SUBJECT: ISSUANCE OF AMENDMENT NO. 51 TO FACILITY OPERATING LICENSE NO.
NPF-62 (TAC NO. 76821)

This amendment revises the pressure-temperature limits in the Clinton Technical Specifications in response to recommendations in NRC Generic Letter 88-11.

CLINTON POWER STATION, UNIT NO. 1

SAFETY EVALUATION BY THE OFFICE OF NUCLEAR REACTOR REGULATION
RELATED TO AMENDMENT NO. 51 TO FACILITY OPERATING LICENSE NO. NPF-62

Figure 3.4.6.1-1. Reactor Vessel Pressure Versus Minimum Reactor Vessel Metal Temperature

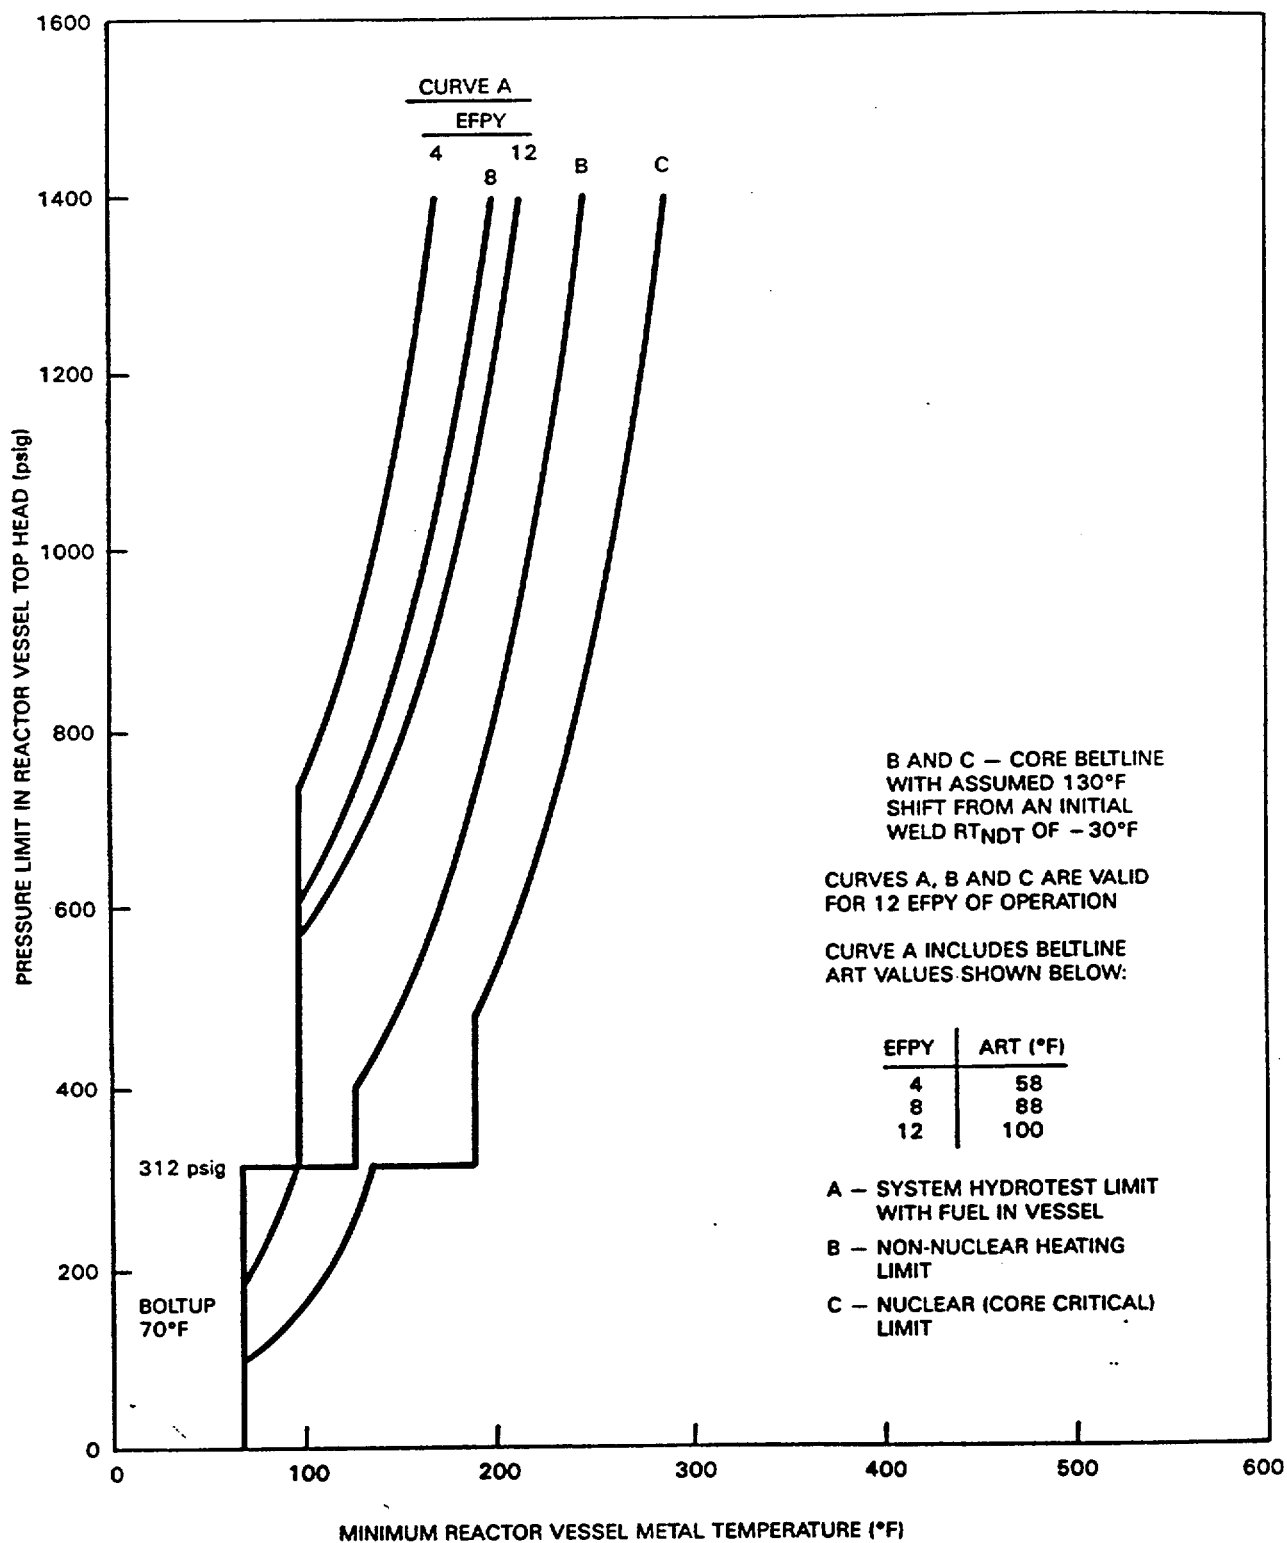
3.4.6.1 The reactor vessel pressure and metal temperature shall be limited in accordance with the limit lines shown on Figure 3.4.6.1-1 (1) curve A for hydrostatic or leak testing; (2) curve B for heatup by non-nuclear means, cooldown following a nuclear shutdown and low power PHYSICS TESTS; and (3) curve C for operations with a critical core other than low power PHYSICS TESTS, with:

4.4.6.1.3 The reactor coolant system temperature and pressure shall be determined to be to the right of the criticality limit line of Figure 3.4.6.1-1 curve within 15 minutes prior to the withdrawal of control rods to bring the reactor to criticality.

4.4.6.1.4 The reactor vessel material specimens shall be removed and examined to determine changes in reactor pressure vessel material properties as a function of time and THERMAL POWER as required by 10 CFR 50, Appendix H, in accordance with the schedule in Table 4.4.6.1-1. The results of these examinations shall be used to adjust the curves of Figure 3.4.6.1-1.

The licensee calculated an almost identical ART of $100^{\circ}F$ for the same weld 76492 using RG 1.99, Rev. 2. The staff considers the difference of $0.3^{\circ}F$ insignificant (100.3 vs $100^{\circ}F$). Substituting the ART of $100.3^{\circ}F$ into equations in SRP 5.3.2, the staff verified that the proposed P/T limits for heatup, cooldown, and hydrotest meet the beltline material requirements in Appendix G of 10 CFR Part 50.

The staff concludes that the proposed P/T limits for the reactor coolant system for heatup, cooldown, leak test, and criticality are valid through 12 EFY because the limits conform to the requirements of Appendices G and H of 10 CFR Part 50. The licensee's submittal also satisfies Generic Letter 88-11 because the licensee used the method in RG 1.99, Rev. 2 to calculate the ART. Hence, the proposed P/T limits may be incorporated into the Clinton Technical Specifications.

Bases Figure B 3/4.4.6-1. Fast Neutron Fluence (E > 1 MeV)
at I.D. Surface as a Function of Service Life

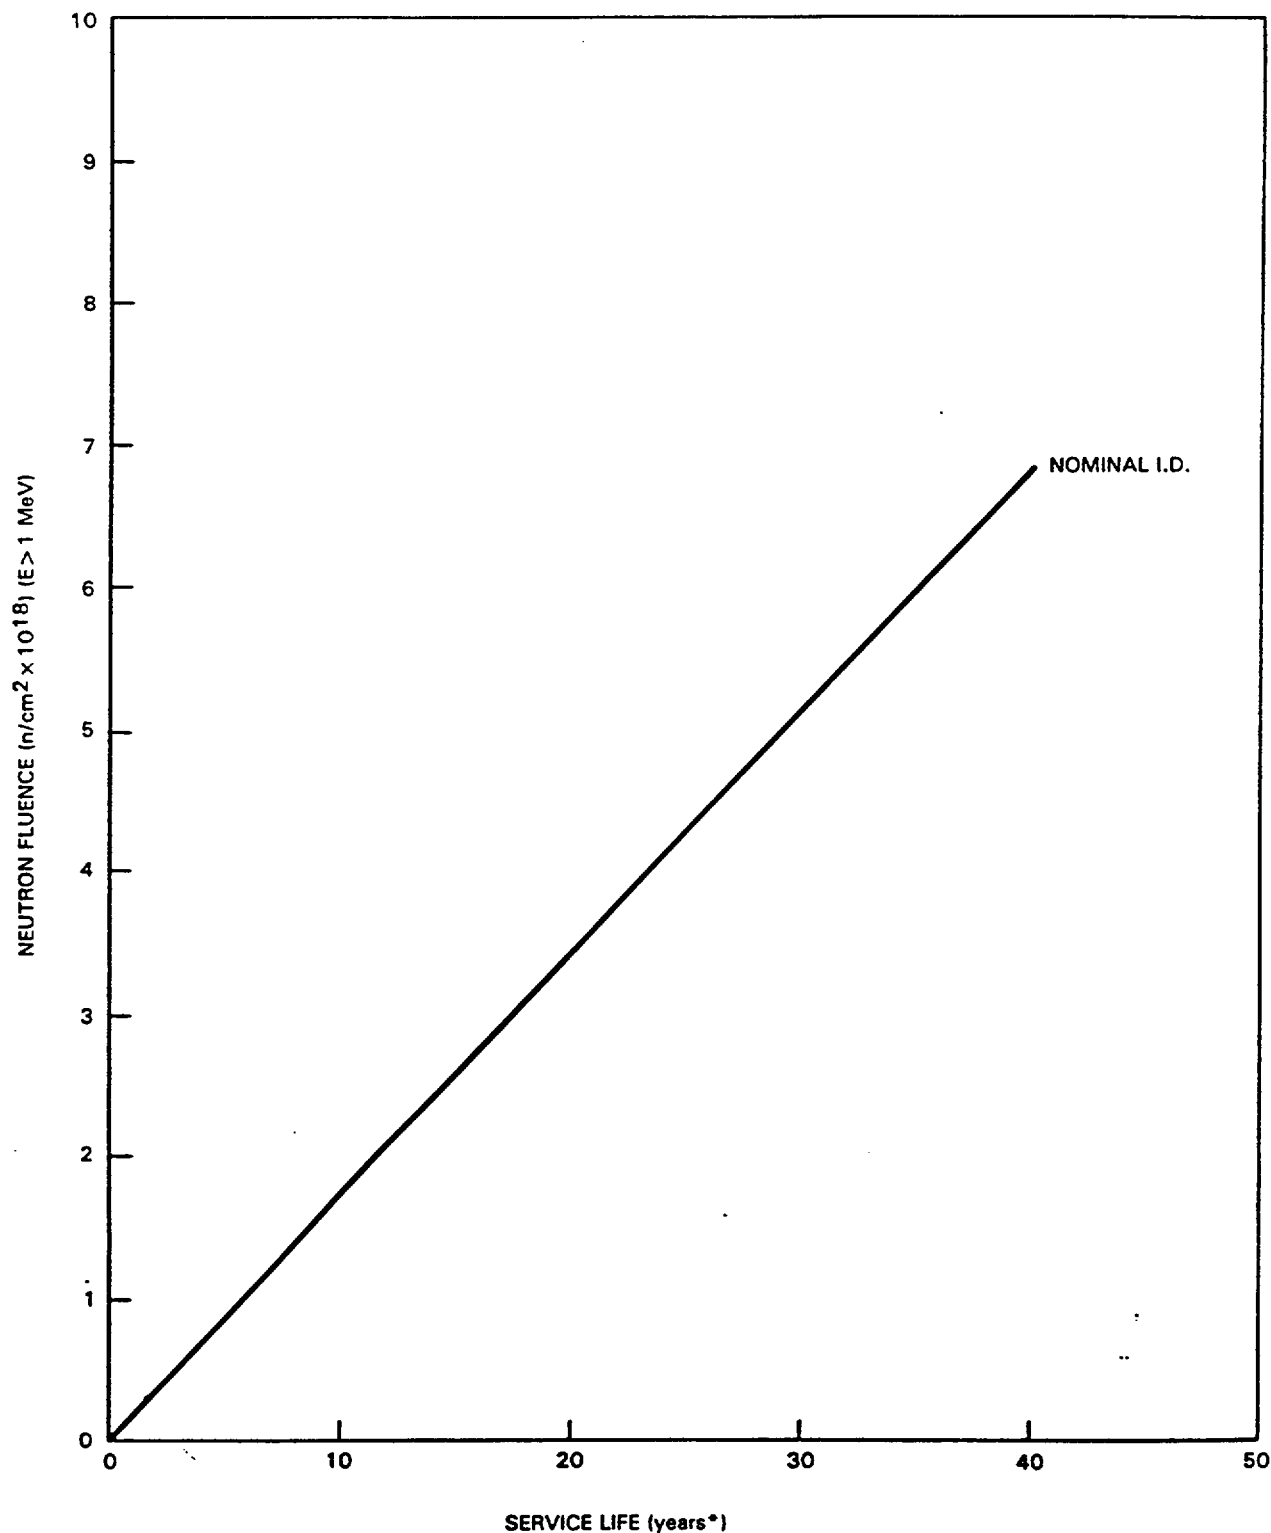
For the limiting beltline material, weld 76492, the staff calculated the ART to be $100.3^{\circ}F$ at $1/4T$ (T = reactor vessel beltline thickness) and $79.6^{\circ}F$ for $3/4T$ at 12 EFPY. The staff used a neutron fluence of $1.85E18$ n/cm² at $1/4T$ and $9.4E17$ n/cm² at $3/4T$. The ART was determined per Section 1 of RG 1.99, Rev. 2, because no surveillance capsules have been removed from the Clinton reactor vessel.
